DEV NUMBER:  
DEV25-0148

TOP-LEVEL SKU P/N(S) AND MODEL NUMBER(S):  
PN177593 MOLD 48116

DEVIATION FORM (DRAWING)

DRAWING NUMBER:	DRAWING REVISION:	DEVIATION REVISION:	DRAWING TITLE/ PART DESCRIPTION:	VENDOR:
177593	H	H3	Gearbox cup	026 EL LAGO

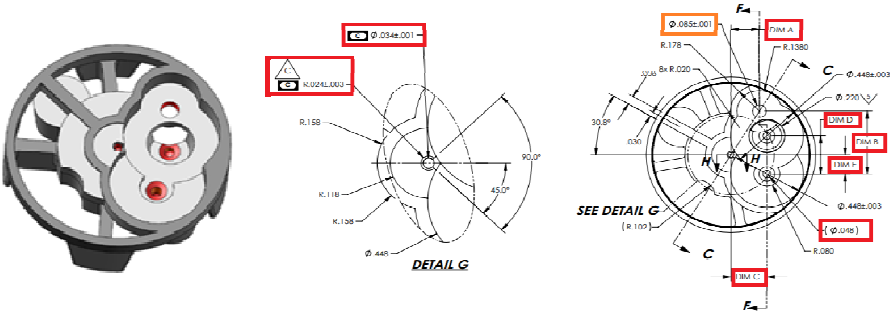
REASON FOR DEVIATION:  
This document aims to accept the Gearbox Cup (PN177593) with DIM "B" out of control for cavities 15 and 19.  
The drawing calls out for DIM "B", mold 48116, a value of .421+/- 0.002 (note 14)  
Quality reported measurements of .4186" (cav 15), and .4187" (cav 19) both dimension out of spec.  
Core pins of CAV 28 was replaced and DIM 0.085 (non critical) is Out of Spec. Quality reported measurements of .0899  
DIM B is a vertical distance between the center of two holes that retain metal shafts in the final gearbox assembly (detail G)  
The team is asking an additional extension on dates for this deviation due to the following facts:

DESCRIPTION OF DEVIATION (IS/WAS CONDITION AND DRAWING ZONE FOR EACH PART NO. OR ATTACH REDLINE PRINTS):

IS

[.421" + .003" - .005"]  
[.085" + .005" - .001"]

WAS

[.421" + .002" - .002"]  
[.085" + .001" - .001"]
